Design of Analog CMOS Integrated Circuits

Behzad Razavi

Errata

Fig. 1.

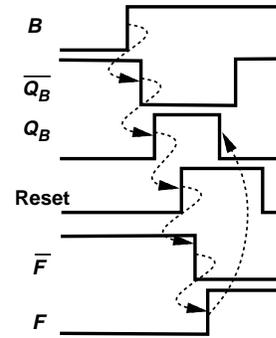
- p. 473, last line: change A_{ux} to A_{aux} .
- p. 518, Caption of Fig. 14.48 should read: (c) largest delay.
- p. 543, sentence above Fig. 15.15 should end as: ... than does $y_1(t)$.
- p. 553, Example 15.8: Waveforms at E and F change simultaneously, leading to a reset pulsewidth of about five gate delays (rather than 10 gate delays).
